OBJECTION TO AMENDMENTS TO DA202240431 - S144C (PROPOSAL FOR SUPPORTIVE HOUSING DEVELOPMENT AND LEASE VARIATION).

2. 5-7 Roe St Griffith - RZ1 - 1,647m² total, (823m² for Block 22, Section 48 + 824m² for Block 21, Section 48).

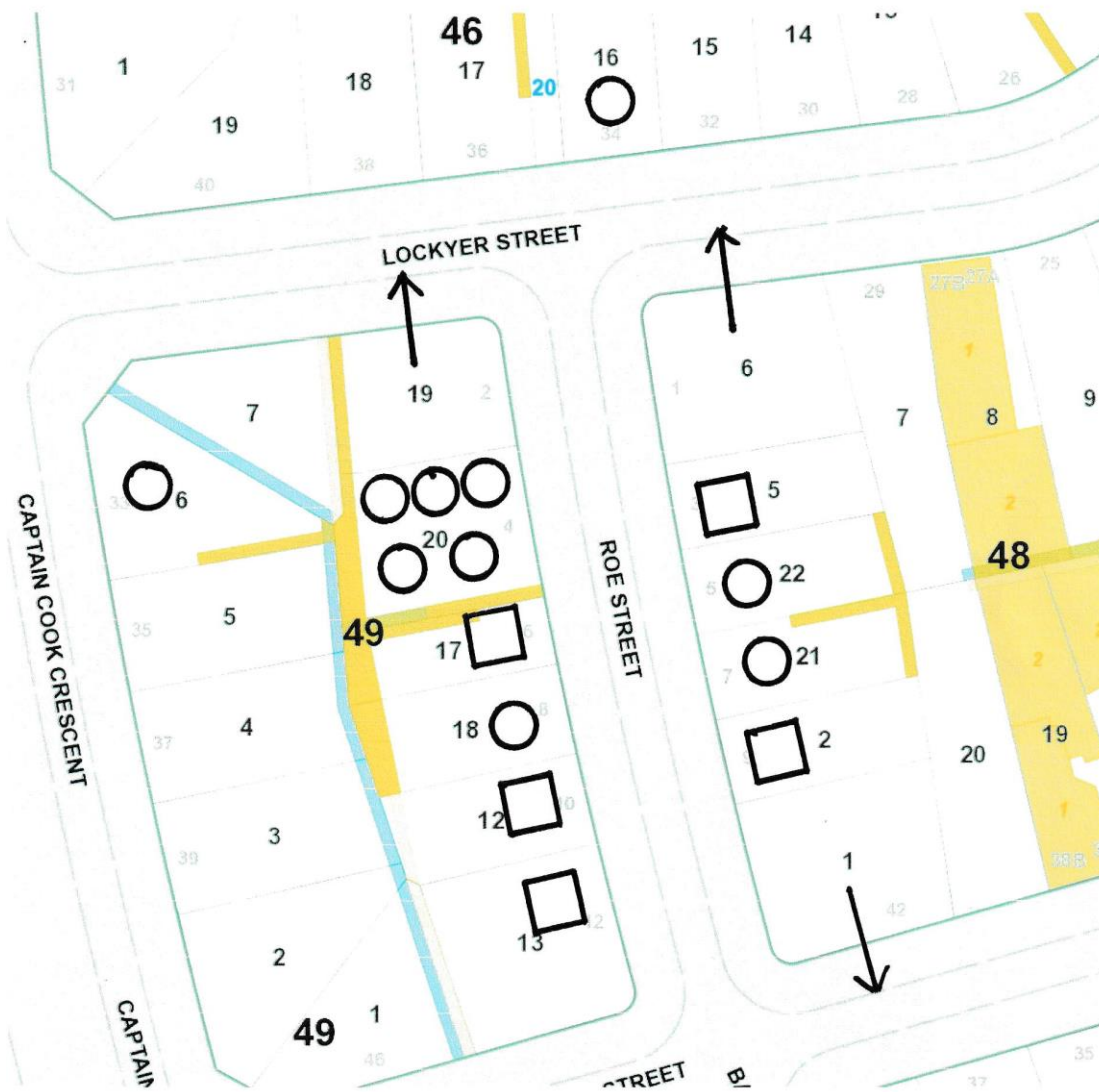
B.3 The proposed development is in Roe Street, which is 150 metres long and has 12 blocks. Of those blocks three are corner blocks with residences facing the adjoining streets so that leaves nine blocks facing, and interacting mainly with, Roe St (see figure B below). Two Roe St blocks have already been joined in a development similar to the proposed development but with five dwellings. On the 9 blocks in Roe St (engaging with Roe St), there are eight public residences and four private (50%) (see Figure B below). The proposed development will increase that number to 10 public residences and four private. If the residences facing the other streets are included it is still 10 public and eight private.

A. Roe Street – Map of Blocks and Sections showing existing public and private residences.

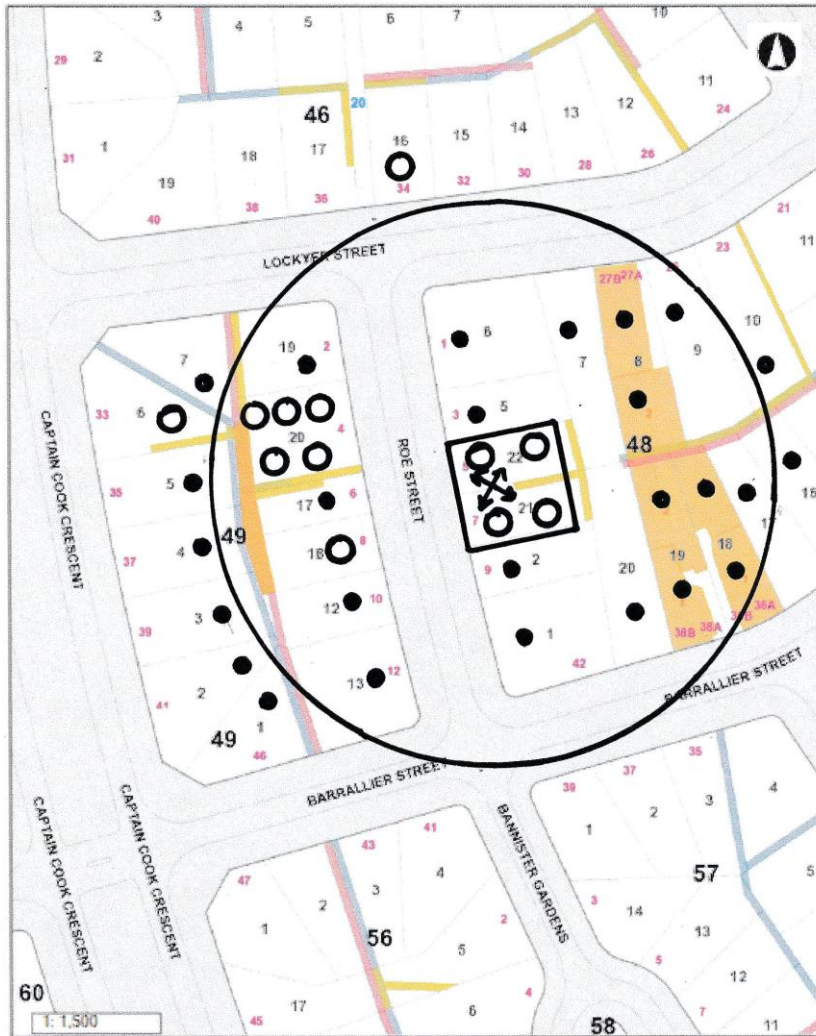
Existing public residences on Roe Street and on adjacent streets
